LVA Addendum

Derril Water Solar Farm

- 1.3. This additional information has been provided in response to the ‘Review of Submitted LVIA, Landscape and Visual Issues’ which was carried out by Peter Leaver BA (Hons) Dip LD CMLI, director of David Wilson Partnership on behalf of Torridge District Council in May 2021.

Review of Submitted LVIA, Landscape and Visual Issues, May 2021.

Derril Water Solar Farm Landscape Character Areas/ Types Figure 1.1

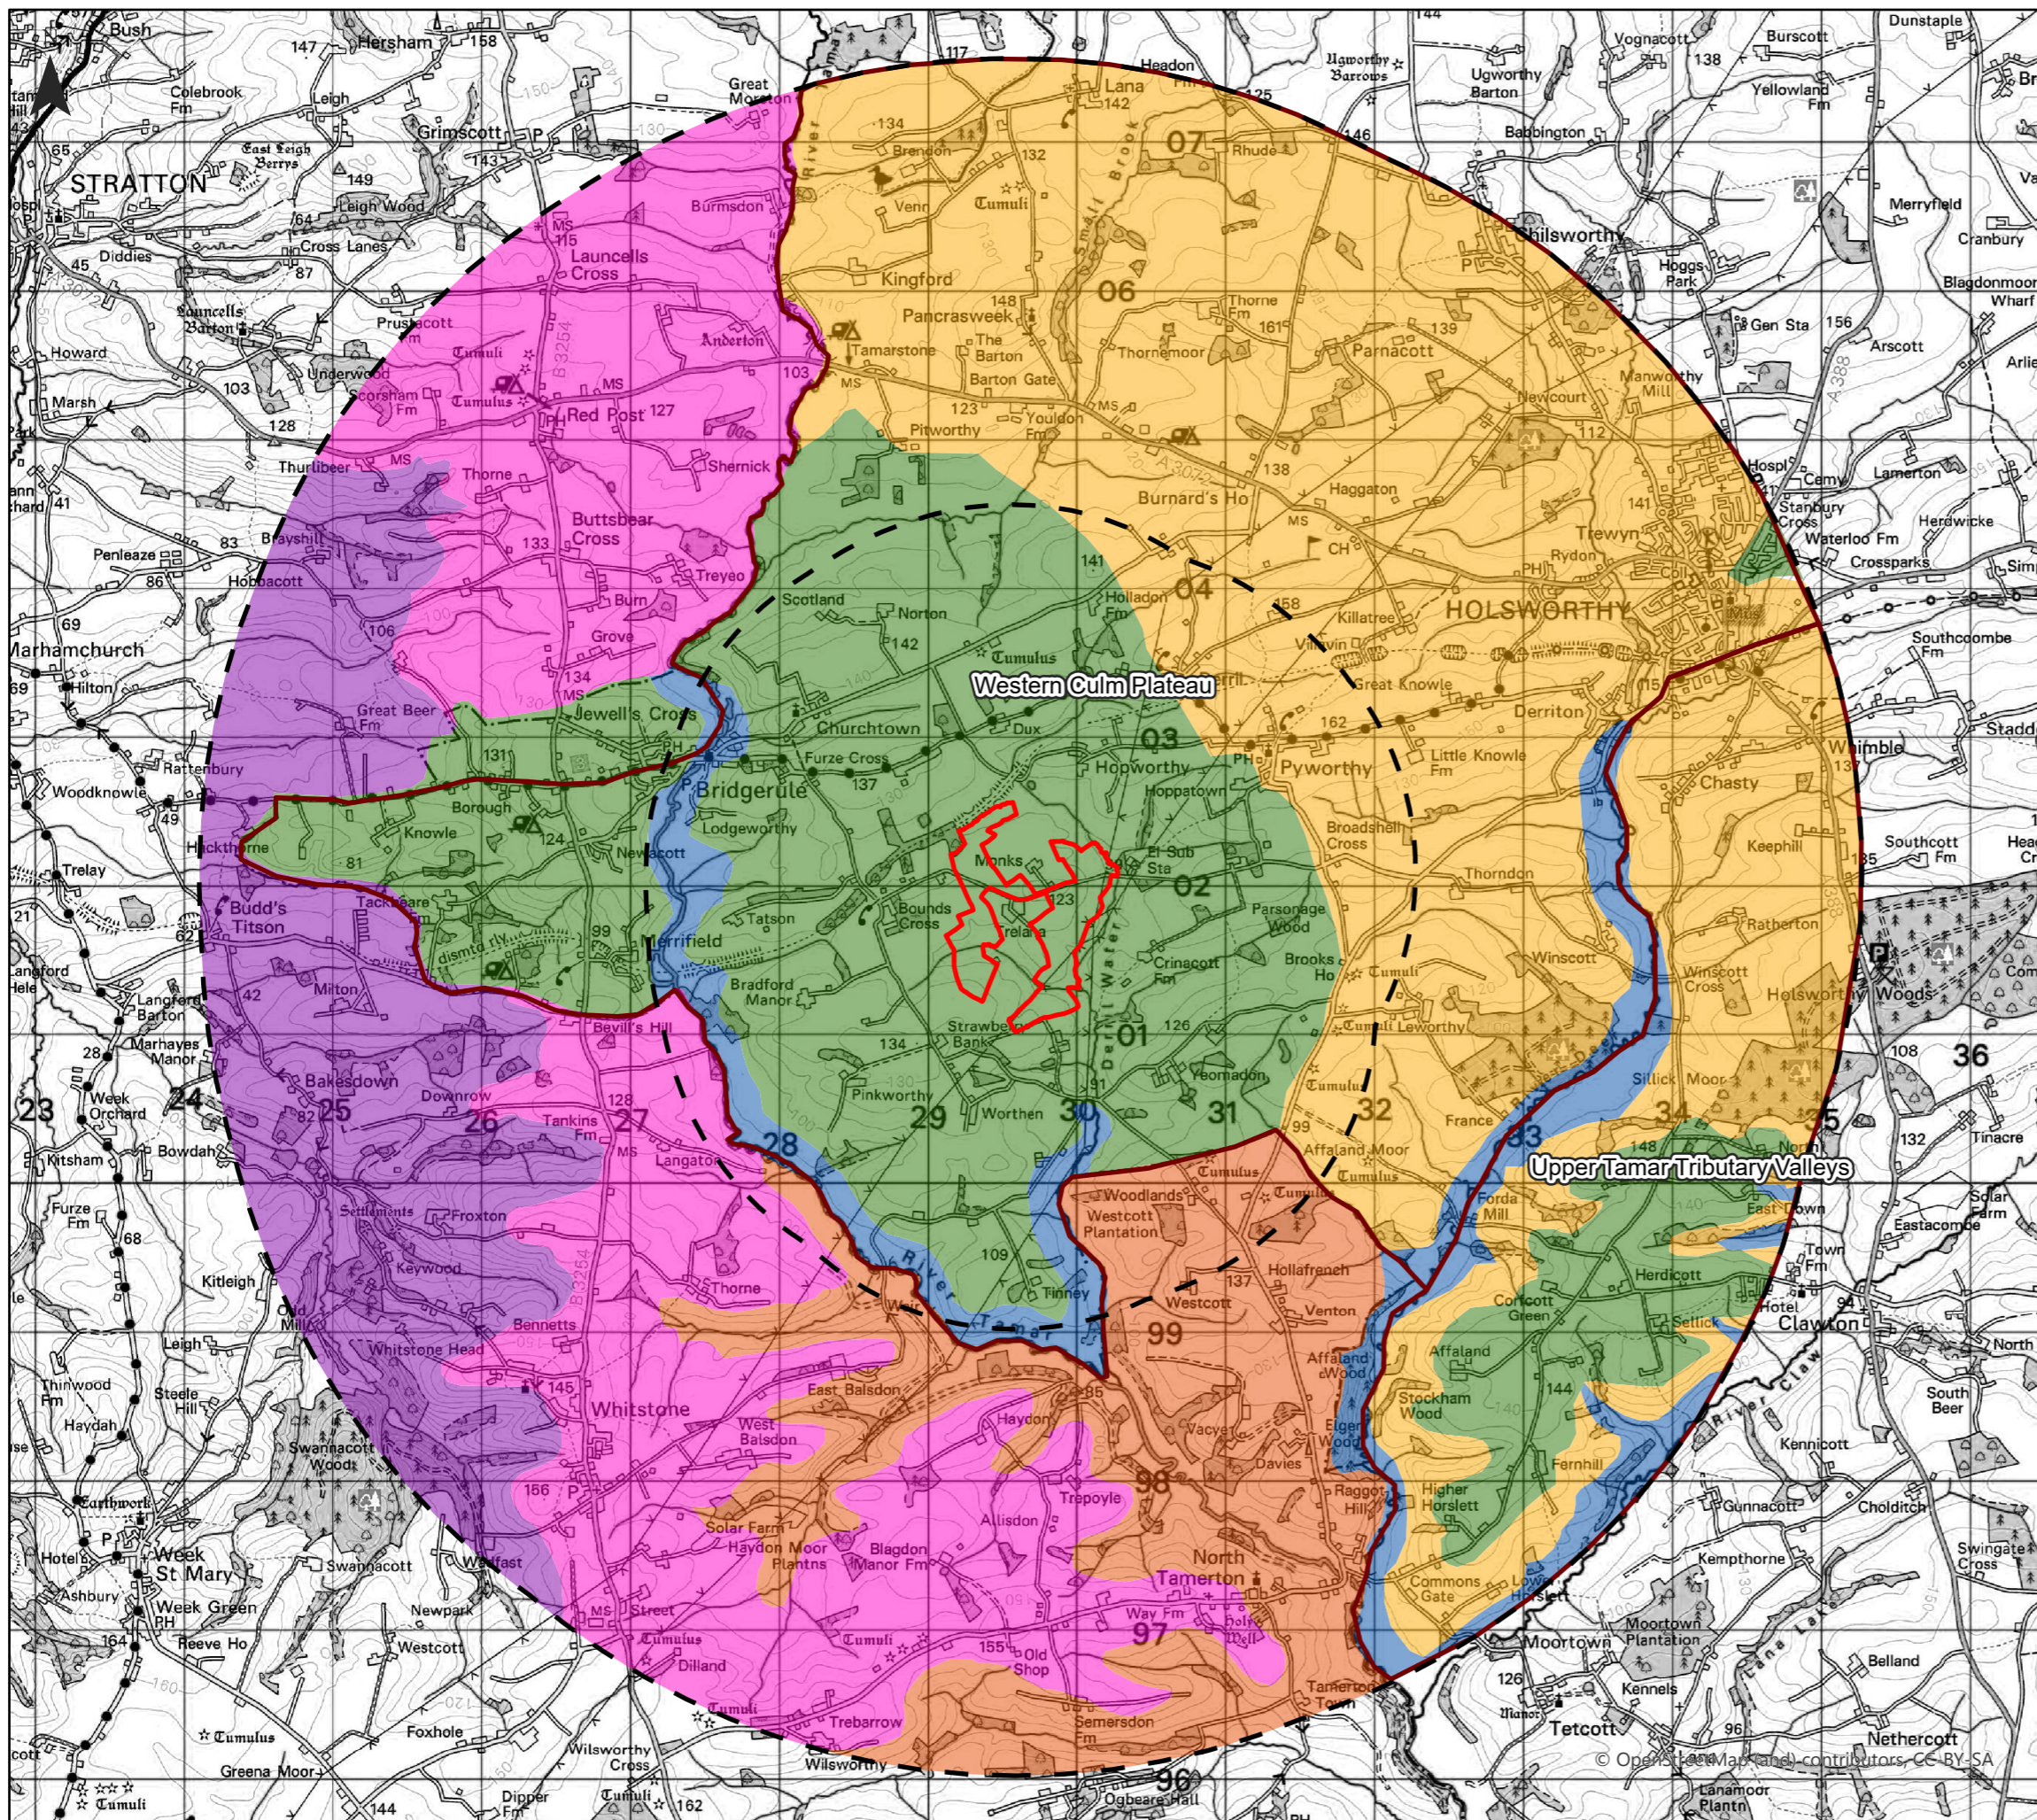
“Baseline Studies: Landscape receptors that will receive direct and indirect effects are comprehensively considered in the baseline study. The Devon Character Assessment has not been referenced and a copy of the relevant section is included in an appendix to this report. A review of the Cornwall Renewable Energy Landscape Assessment is at consultation stage and was not included in the baseline information.”

“Devon Character Area (DCA) Western Culm Plateau not considered.

Some of the qualities and characteristics of the Western Culm Plateau DCA are susceptible to change as a result of development. Their assessment is an omission from the LVIA. I have carried out an outline assessment of impacts using the LVIA methodology. The Cornwall review of their 2007 renewable energy sensitivity study is available now in draft form and it’s conclusions noted in my review of the effects on CA31.”

- 1.4. This addendum is supported by:
 - A revised **Figure 1.1** – Derril Water Solar Farm Landscape Character Areas / Types located in **Appendix A**
- 1.5. Other figures that are referred to from the submitted LVIA are:

1.8. The Devon Landscape Character Assessment identifies 68 Devon Character Areas, which share a unique and distinct identity recognisable at a county scale. At a national scale the study area is within the National Character Area (NCA) 149 The Culm¹. Within each Devon Character Area there comprises a number of different Landscape Character Types (LCT) which are identified in the Joint Landscape Character Assessment for North Devon & Torridge Districts, 2010². The three Torridge Landscape Character Types within the 5km study area for the Proposed Development Site are considered in the submitted LVA. These are 5A – Inland Elevated Undulating Land, 1F – Farmed Lowland Moorland and Culm Grassland and 3C – Sparsely Settled Farmed Valley Floor. The Devon Character Areas within the 5km study area are Western Culm Plateau (DCA) and Upper Tamar Tributary Valleys (DCA).

1.9. Although the county scale landscape character was not assessed as part of the original LVA submitted in March 2021, at a more detailed scale, both the relevant National Character Areas and Landscape Character Types were assessed. The wider county scale DCA is assessed as part of this addendum. It is also worth noting that the *Cornwall Renewable Energy Sensitivity Study* which is currently in draft form was not assessed as part of the originally submitted LVA because it was not publicly available at the time of writing. This will eventually replace the
